Work Order ID 96954

Item Name: Crosstube Turning Detail

DART AEROSPACE LTD	Work Order:	96954
Description: Crosstube Assembly (412 High Aft)	Part Number:	D412-664-243
Inspection Dwg: D412-664-243 Rev: E		Page 1 of 2

DRAWING NO. D412-664-243	TITLE CROSSTUBE ASSEMBLY (412 HI AFT)	REV. E	DART AEROSPACE LTD ENGINEERING ORDER		D.E.O. NO. D412-664-243-E-1	SHEET NO. SHEET 1 OF 2	SCALE NTS
DRAWN	CHECKED	MFG. APPR.	APPROVED	DE APPR.			
DATE 11.03.31	DATE 11/03/31	DATE 11.03.31	DATE 11/03/31	DATE 11.03.31

**D412-664-243
ASSEMBLY DETAIL**

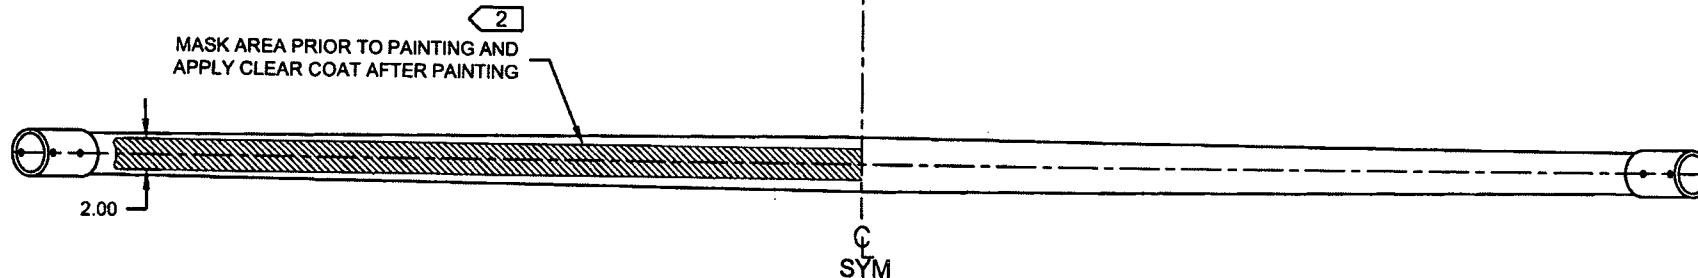
REMOVED ABRASION STRIP IN FAVOR OF A THIN LAYER OF PROSEAL 890.

D2856-600-1009 ABRASION STRIP
D3189-1 CHAFING SHIELD (1, INSTALLED OVER ABRASION STRIP)
MS21920-28 CLAMP, 2X
2 PL

D3189-1 CHAFING SHIELD (1, INSTALLED OVER PROSEAL 890)
MS21920-28 CLAMP, 2X
2 PL

**D412-664-243
ASSEMBLY DETAIL**

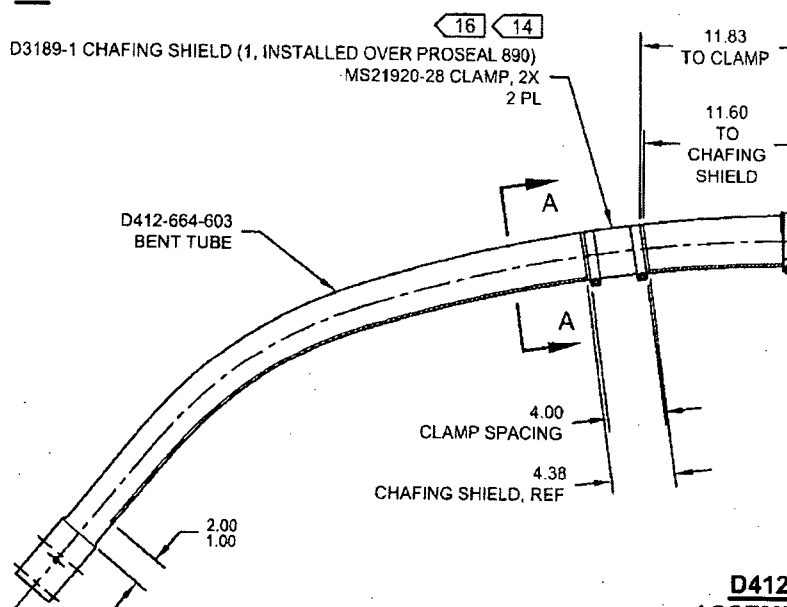
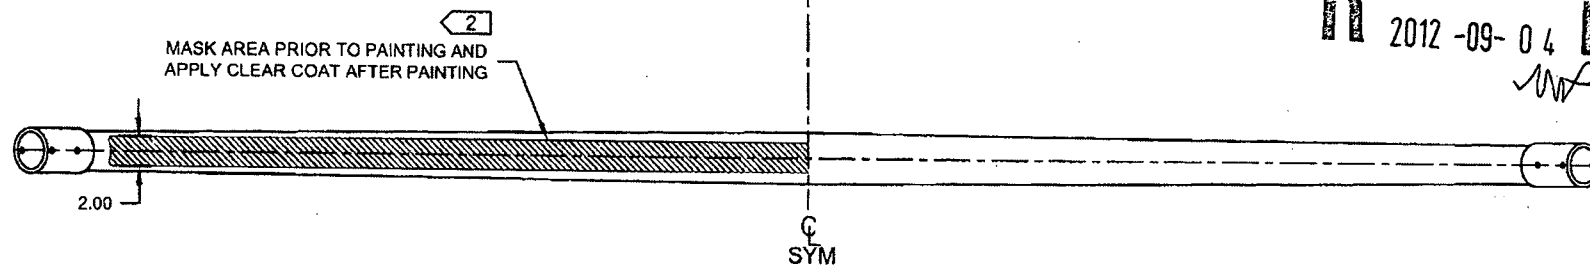
D2866-600-1009 ABRASION STRIP
D3189-1 CHAFING SHIELD (1, INSTALLED OVER ABRASION STRIP)
MS21920-28 CLAMP, 2X
2 PL

D3189-1 CHAFING SHIELD (1, INSTALLED OVER PROSEAL 890)
MS21920-28 CLAMP, 2X
2 PL
